SERVICE DIRECTIVE BULLETIN NO. T-034

DATE: October 13, 2008

1. SUBJECT: Possible Interference Involving Main Rotor Pitch Change Bellcrank (Cyclic Walking Beam)
2. MODEL: TH-28 and 480 Series
3. EFFECTIVITY: All serial numbers
4. BACKGROUND:

**Figure 1. Damage to ear of bellcrank.**

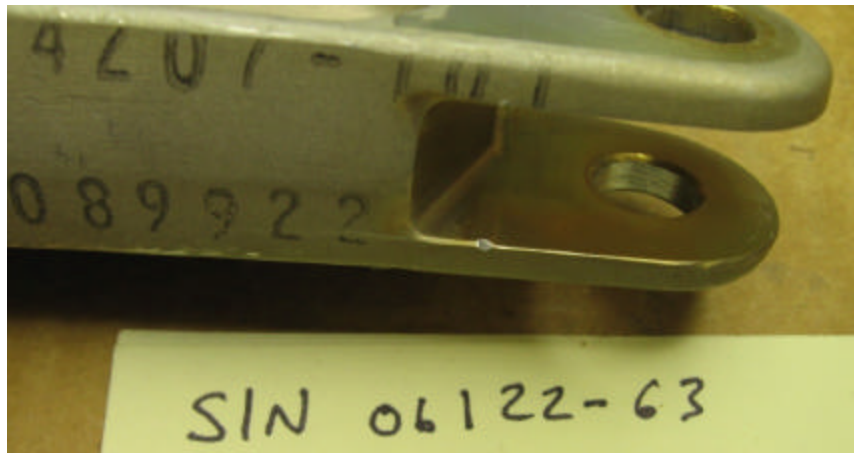
Within the next 25 hours time in service, visually inspect the ears of the pitch change bellcranks for damage caused by contact with the main rotor control rods in accordance with (IAW) paragraph 5.1.A. If contact damage is found, inspect the rigging of the collective system at the bottom of main rotor gearbox IAW paragraph 5.1.B.

- A. Inspect the pitch change bellcranks for contact damage by moving the collective to the mid-range position and using a mirror to inspect for the damage or disconnect the pitch change bellcranks from the main rotor control rods and the bellcrank brackets. Follow the procedures for collective friction use and removing the pitch change bellcranks as found in the TH-28/480 Series Maintenance Manual. If contact damage is found (see Figure 1 for example), refer to paragraph 5.2 for repair procedures and check the rigging of the collective system at the bottom of the main rotor gearbox IAW paragraph 5.1.B. If no contact damage is found, perform the collective system rigging check at the next 100 hour/annual inspection.

- A. Remove the Pitch Change Bellcranks from the helicopter following the procedures in the TH-28/480 Series Maintenance Manual.
- B. Replace pitch change bellcranks with damage exceeding .040" / 1.01mm in depth. Using a small file or other suitable device remove the contact damage from the ears of the pitch change bellcranks; blend the repair area over the length of the ear (the repair cannot exceed 0.040" / 1.01mm in depth). Apply a protective coating of epoxy primer (Desoto #593 X 300 or equivalent) to the repair area.
- C. Reinstall the Pitch Change Bellcranks following the procedures in the TH-28/480 Series Maintenance Manual.

**Figure 2. Required clearance between the collective bearing housing and the swashplate mount flange.**

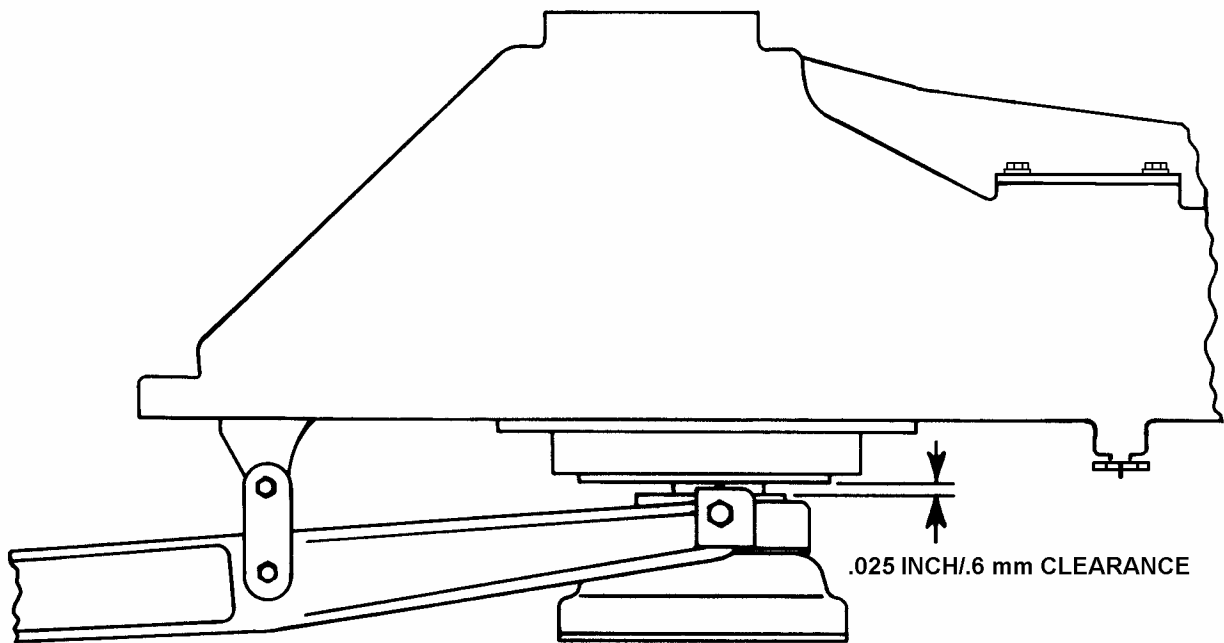
- B. Inspect the rigging of the collective system at the bottom of the main rotor gearbox for .025" (.6 mm) clearance between the collective bearing housing and the swashplate mount flange (See Figure 2). Refer to the TH-28/480 Series Maintenance Manual for the rigging procedures.
